Town of Medway
DESIGN REVIEW COMMITTEE
155 Village Street
Medway MA 02053
508-533-3291
drc@townofmedway.org

March 7, 2017

RE: DRC Sign Design Review Letter
Shell Gasoline, 86 Main Street

Shell
86 Main St.
Medway, MA

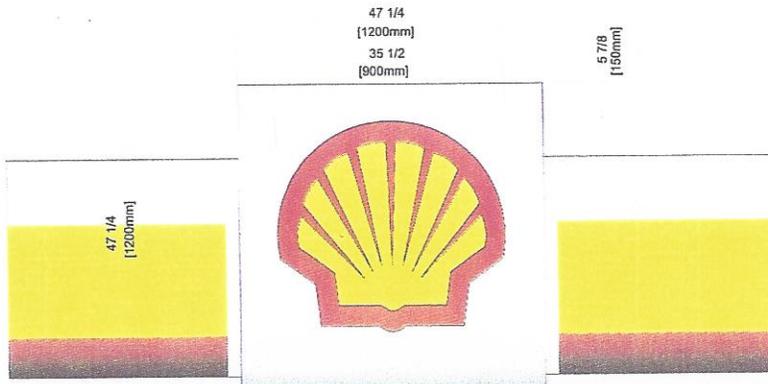
Wall Sign on Canopy – This sign replaces the words “Shell” on the gas canopy with the Shell corporate logo. This is an equal size replacement. The current Shell text sign is 16 sq. ft. internally illuminated. The proposed new shell logo sign is 16 sq. ft., also internally illuminated.

STANDARD - 4x4 PRICE FACE
RVle GLOBAL-(1)16" LED (1)8" LED (1)1X VC - in SHELL MODIFIED CABINET

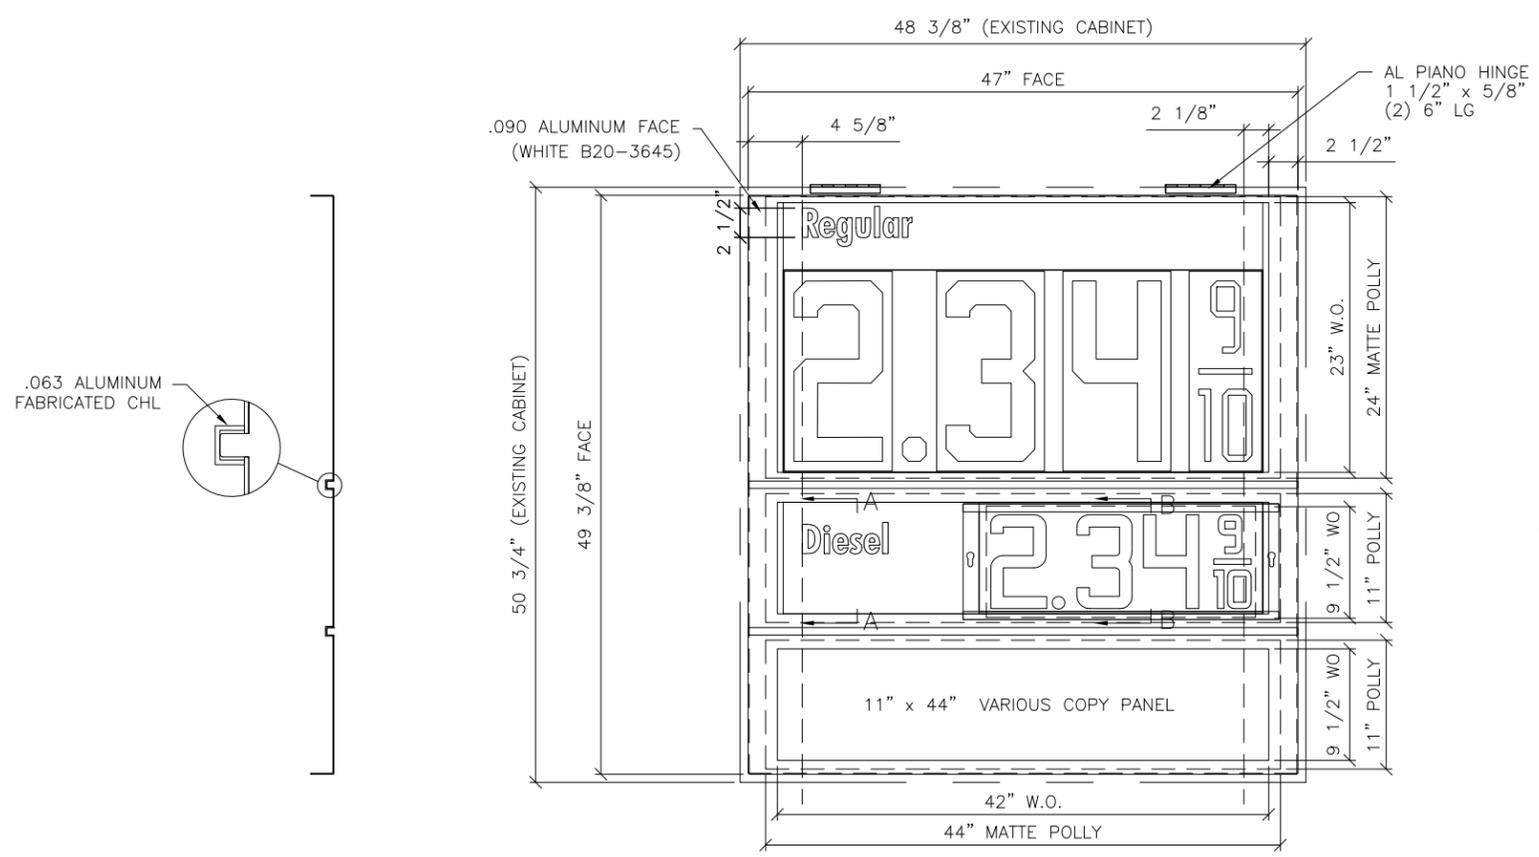
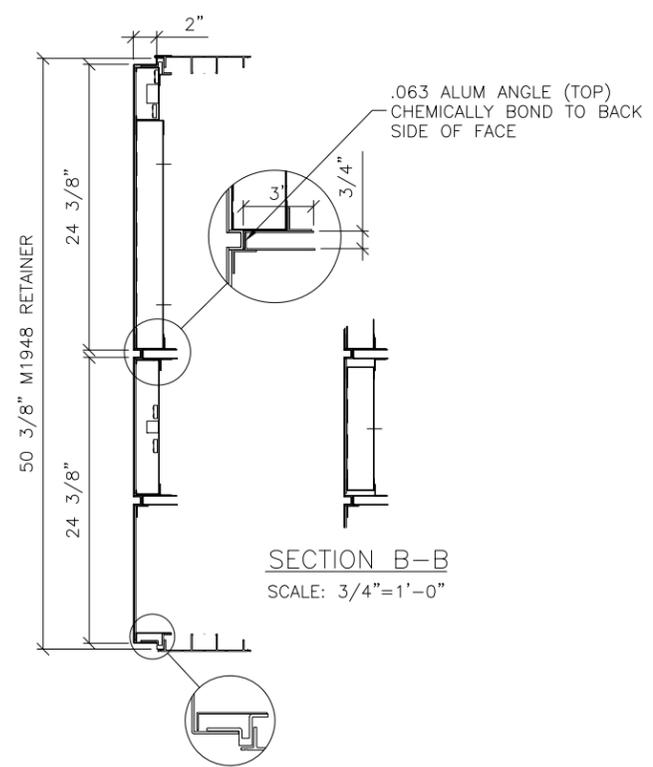
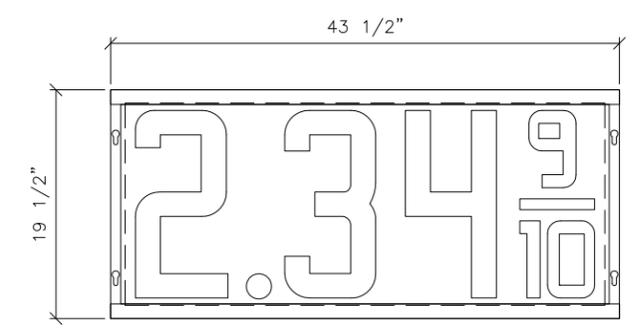
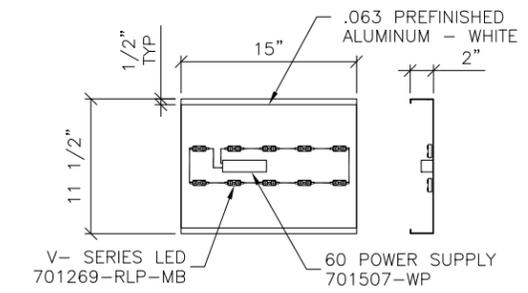
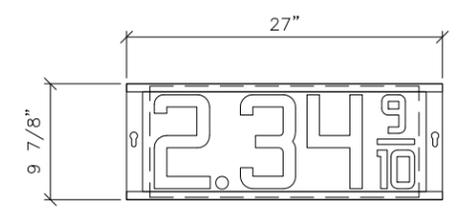
- The sign features LED panels with gasoline prices, which have been enlarged to include a second line for diesel fuel in green. The new LED fuel price portion of the sign is approximately 42.25 sq. inches over the allowable amount per side of the sign that can be dedicated to LED fuel price information. 7.6 sq. ft. of LED lights are shown on each side. The maximum allowed area of LED lights for fuel prices is 7.3 sq. ft. per side.
- The overall height of the sign is 12', the same as the previous sign. The maximum height per the bylaw is 8'. So, the sign height is also non-conforming.

- The LED portion of the sign has been expanded to a second line in green to include diesel fuel, putting it over the allowable size for LED portion of the sign. The DRC recommends the following courses of action to address the non-complaint LED portion of the sign:

1. The LED portion features a screen made up of diodes which can be programmed to illuminate the chosen information. Within the two screens, the size of the illuminated numeric font should be reduced to bring it into compliance. This would create some additional black space behind the sign.

2. If decreasing the LED font size is not achievable, remove the diesel LED section completely, and replace that with a non-illuminated signage necessitating manual gas price changes.

3. On any LED sections of the sign, adjust the illumination level to the lowest visible setting.
